Product Change Notification

PCN # 0470488-PCN

XMBS Gen 1 Firmware Version 1.1

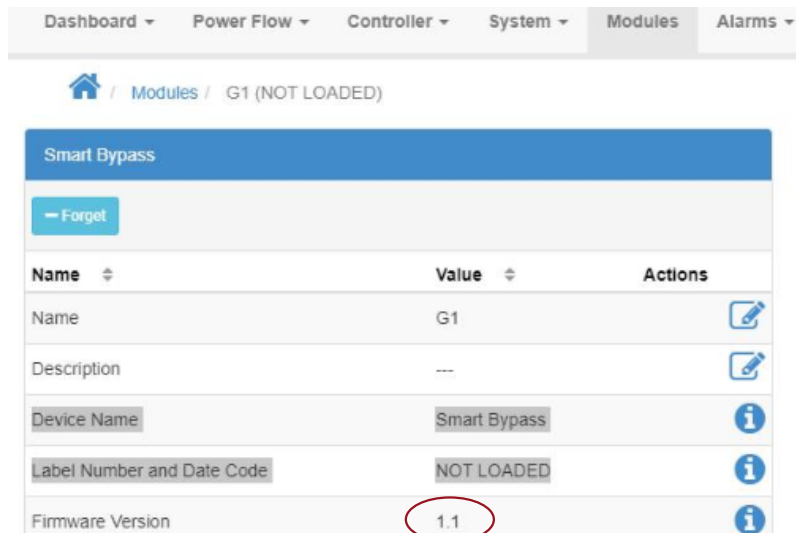
10. Drawing Number 0350150-001_B_XMBS_README_V1.1.pdf	
11. Classification of Change B	12. Reason for Classification This change results in better operation.
13. Reason for Change Functional improvements on XMBS Gen 1 manufactured before January 1, 2021 due to continuous testing and feedback.	
14.1 Description of Change New Features and Improvements: <ul style="list-style-type: none">• Phase angles always displayed as positive numbers• Improved help screens when switching into Auto mode• Improved error checking and reporting• Display hardware and software version on the bypass “schematic” screen	
14.2 Change Verification Procedures Select the middle of the LCD to open “BYPASS STATUS”, firmware version is in the bottom right corner.

Alternatively, sign in to the Cordex Controller (software version 7.01 or later) and go to the **Modules** page to confirm the firmware version is 1.1.

24. Comments

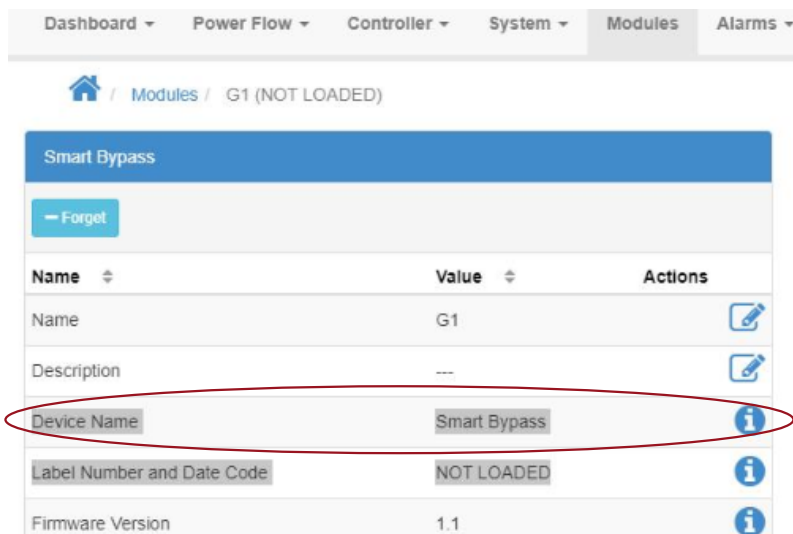
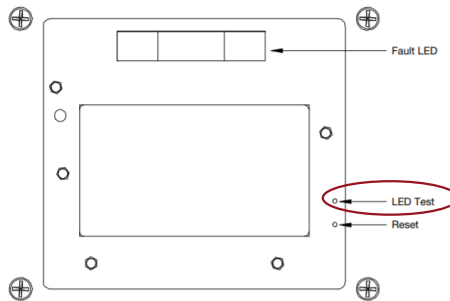
XMBS Gen 1 devices manufactured before January 1, 2021 can be easily identified from the LCD panel as they do not have a LED Test pin hole nor have “G2” in the **Device Name** on the web interface.
